ADDENDUM NUMBER #1

<u>PROJECT</u>	<u>BIDS DUE</u>
Village of Bellaire CWSRF Project #5910-01 WWTP Improvements GFA Project No: 24024	Date: June 24, 2024 Time: 9:00 AM Location: Village of Bellaire 202 N Bridge St., Bellaire, MI 49615

VILLAGE OF BELLAIRE
WASTE WATER TREATMENT PLANT IMPROVEMENTS
DETAILED SITE PLAN
 SECTION 30, T.30 N., R.7 W.
 VILLAGE OF BELLAIRE, ANTRIM COUNTY, MICHIGAN

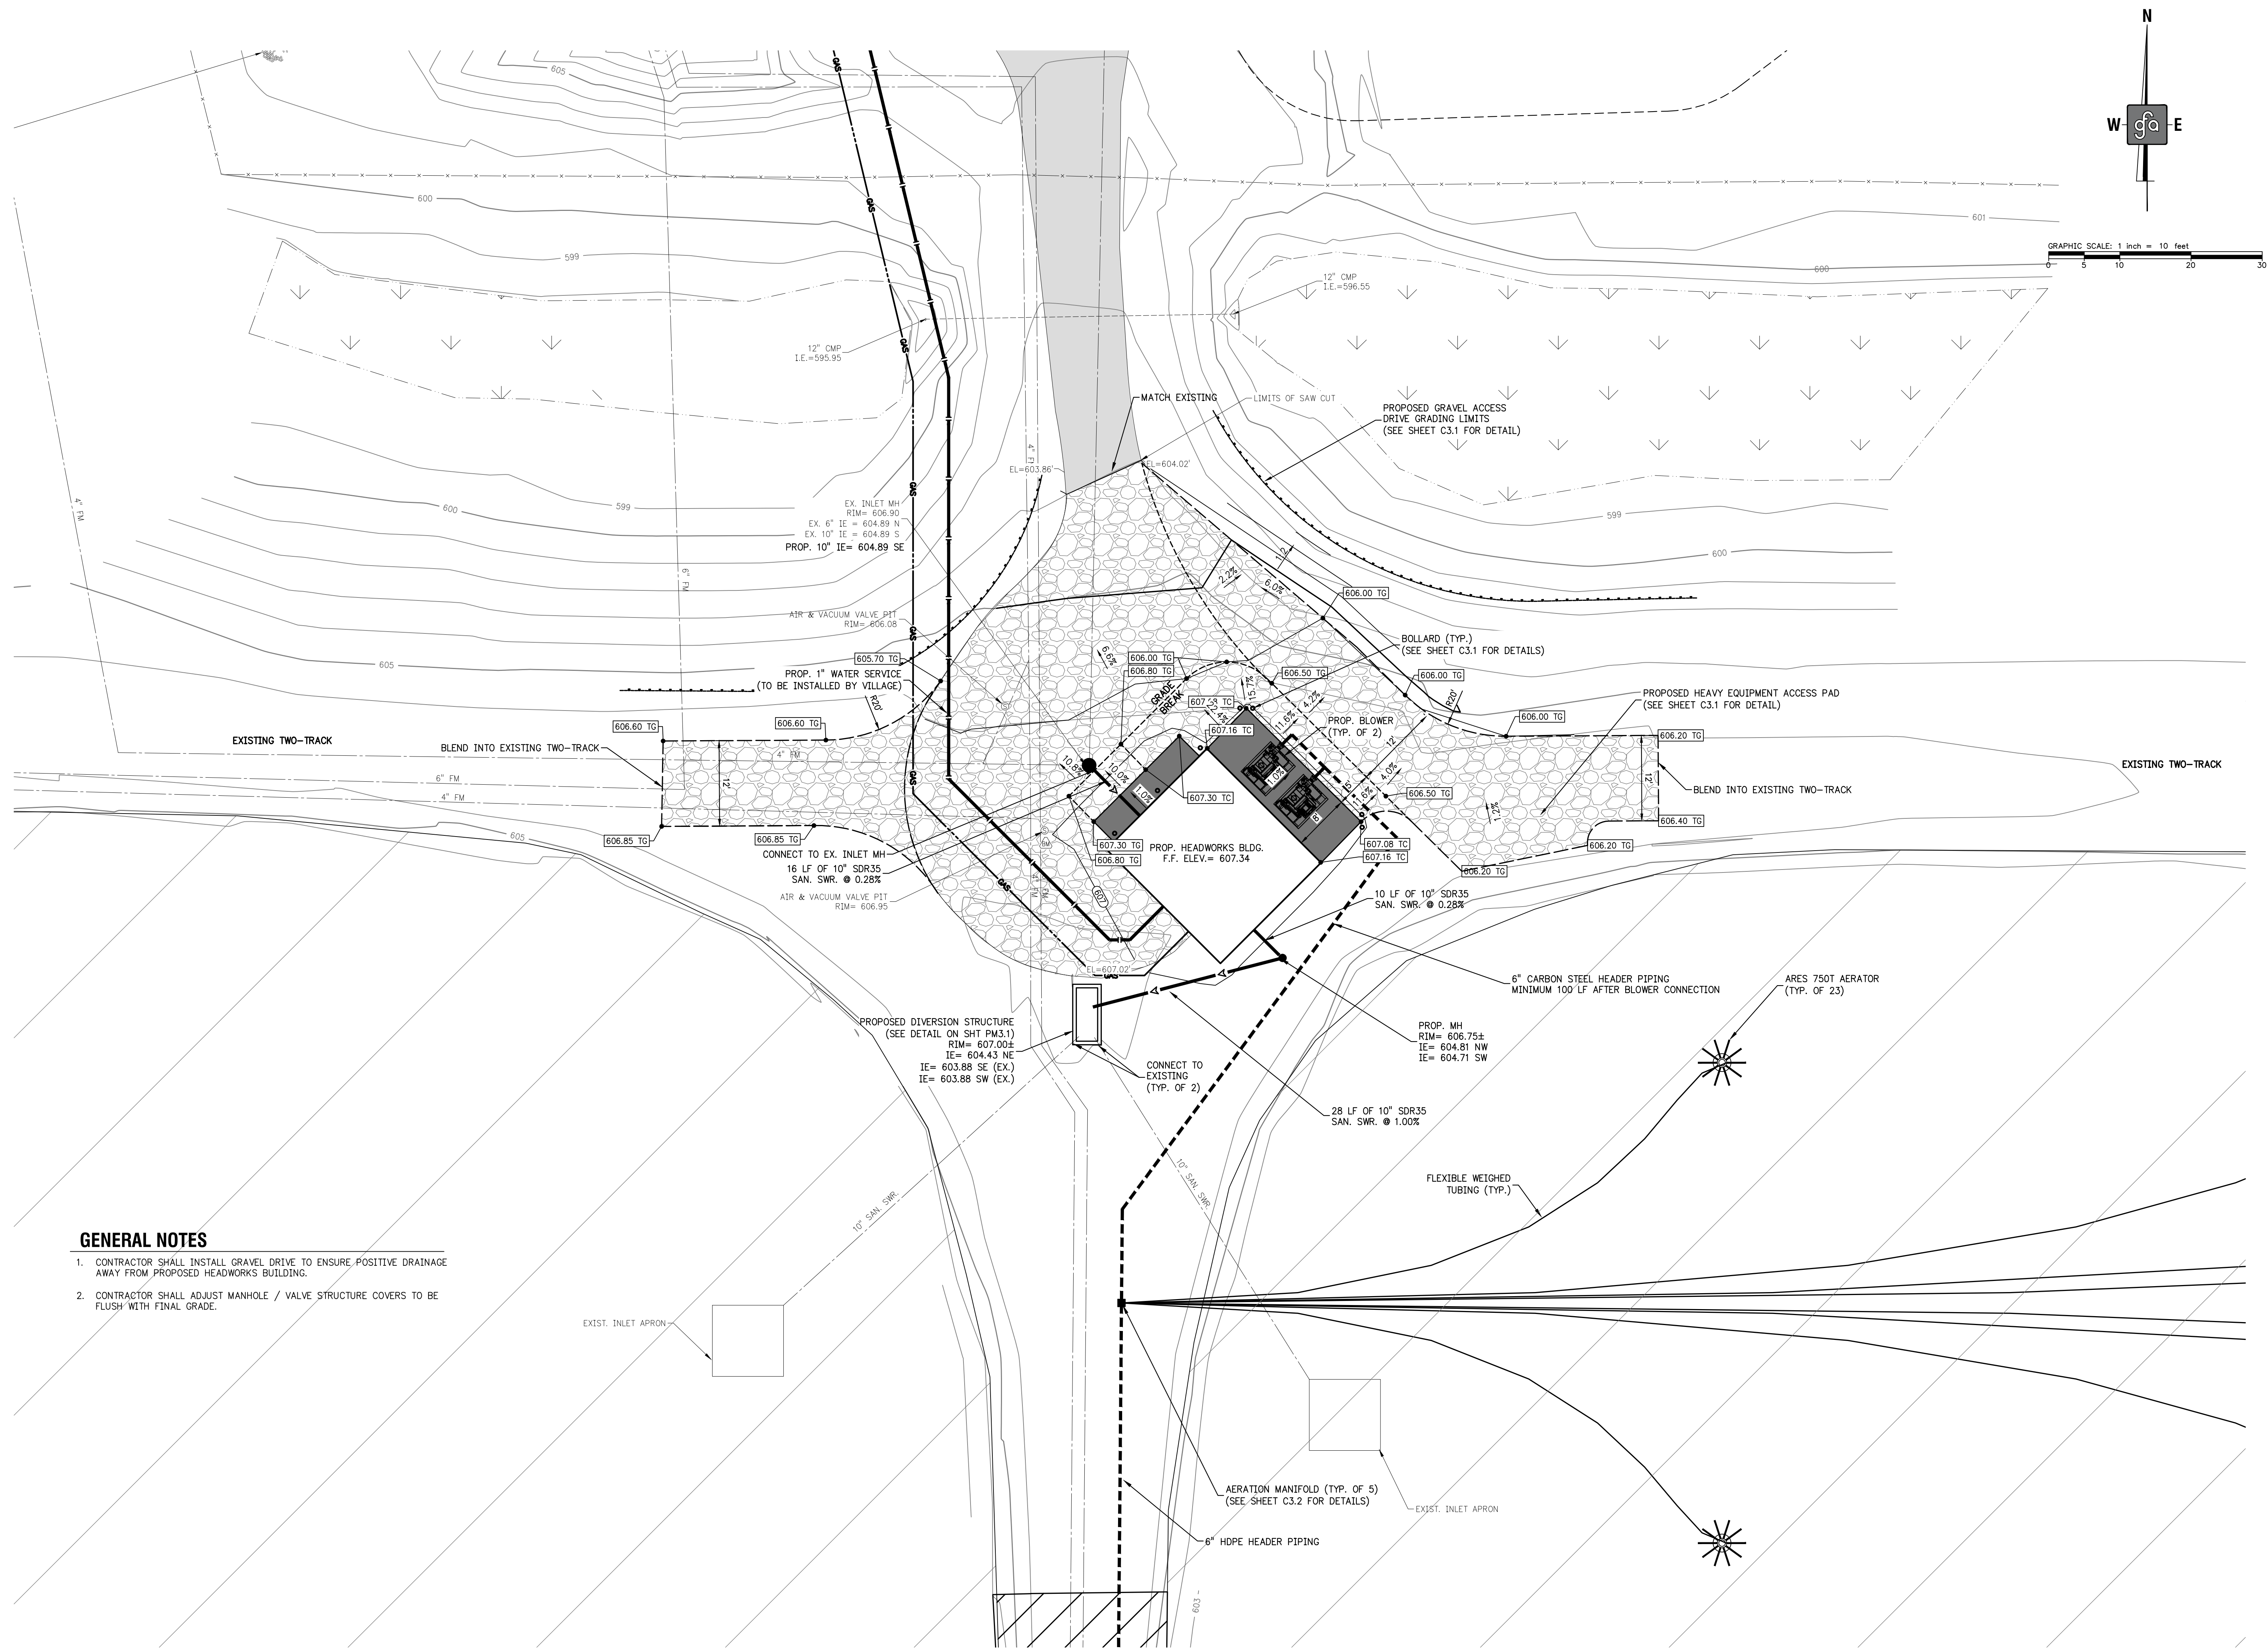
1. Sheets C2.4, C2.5, A2.1, and E1.1 have been updated and incorporated into this Addendum and shall supersede the previous sheets.
 - a. C2.4 - site grading plan modifications
 - b. C2.5 - Monitoring well construction note clarifications and access drive construction detail have been added
 - c. A2.1 - Detail B/A.21 has been updated to clarify only new CMU structures are to be painted. There is no existing CMU structures.

1. CONTRACTOR SHALL INSTALL GRAVEL DRIVE TO ENSURE POSITIVE DRAINAGE AWAY FROM PROPOSED HEADWORKS BUILDING.
2. CONTRACTOR SHALL ADJUST MANHOLE / VALVE STRUCTURE COVERS TO BE FLUSH WITH FINAL GRADE.

ELECTRICAL FLOOR PLAN
SCALE: 1/2" = 1'-0"

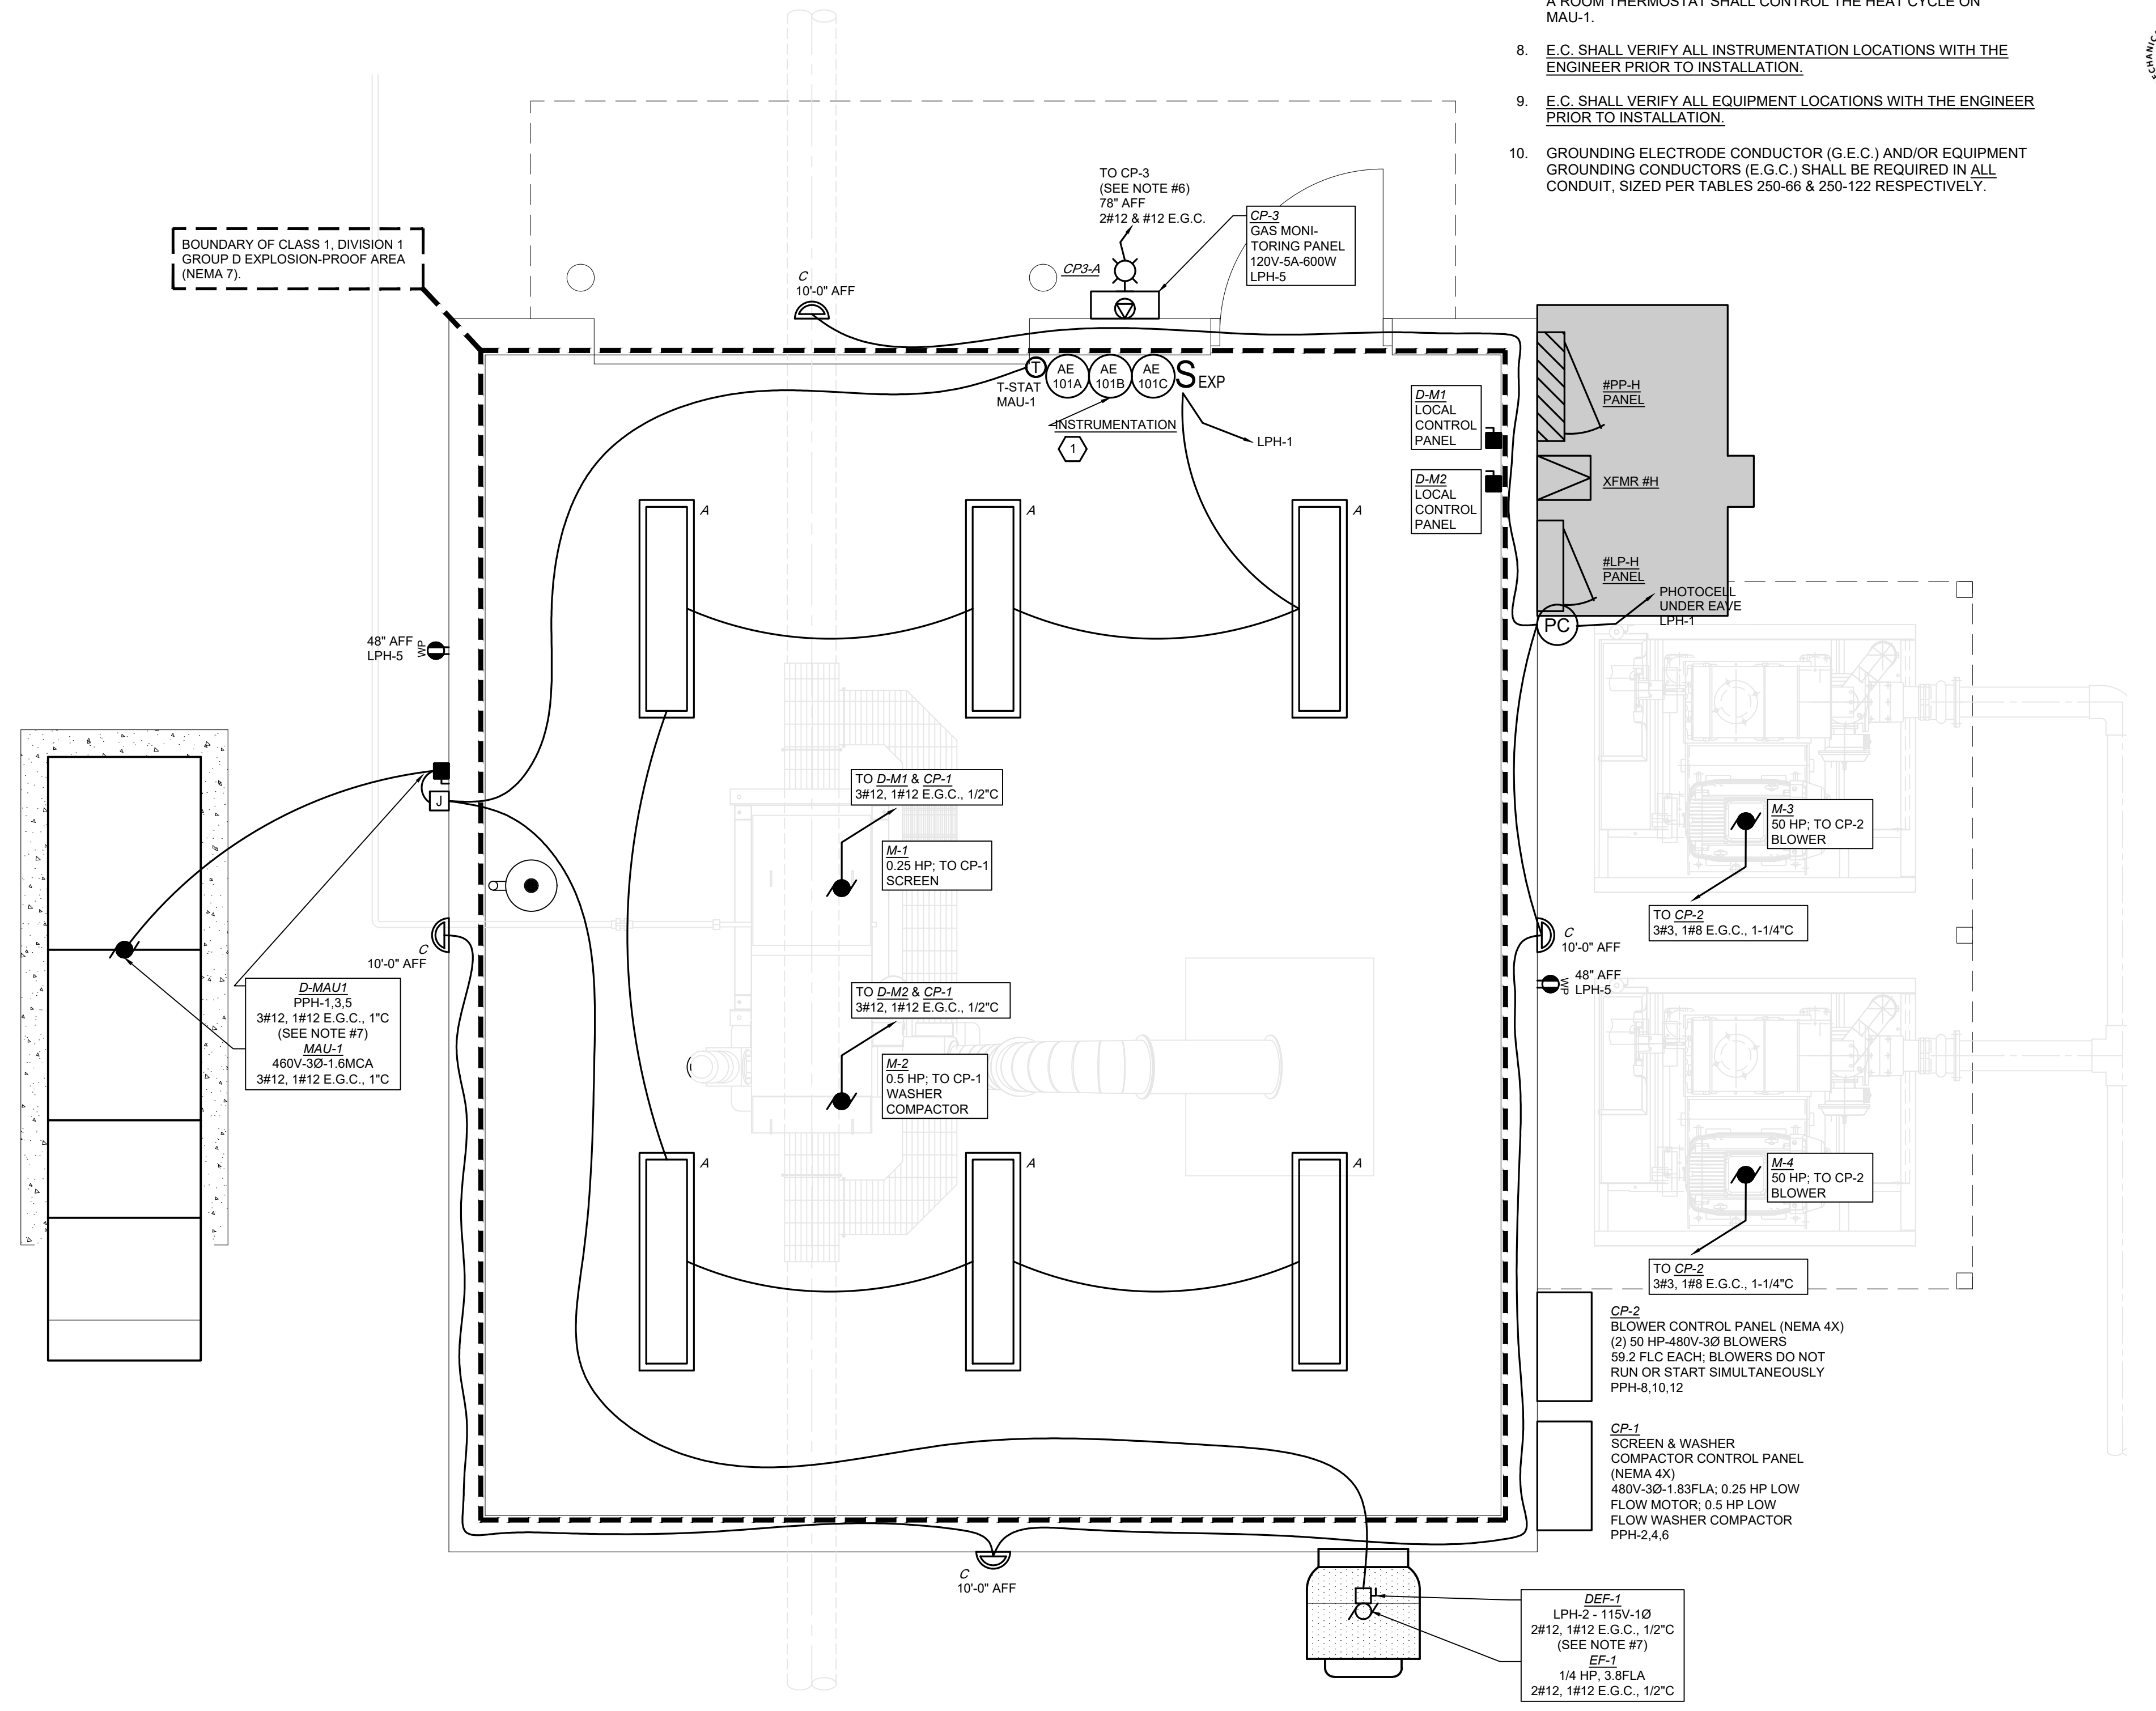
- d. E1.1 – Screening Building is classified as Class I, Division I.

- NOTES**
- ALL ELECTRICAL EQUIPMENT AND WIRING METHODS SHALL MEET LATEST ENFORCEABLE EDITION OF THE N.E.C. CLASS 1, DIVISION 1, GROUP C & D, HAZARDOUS LOCATIONS IN SCREENING ROOM #100.

- ALL ELECTRICAL PIPING IN CLASS 1, DIVISION 1, GROUP C & D SHALL BE PVC COATED RIGID CONDUIT, SURFACE MOUNTED. ALL OTHER CONDUIT SHALL BE (GRS) UNLESS NOTED OTHERWISE ON DRAWINGS. USE PVC CONDUIT STRAPS.
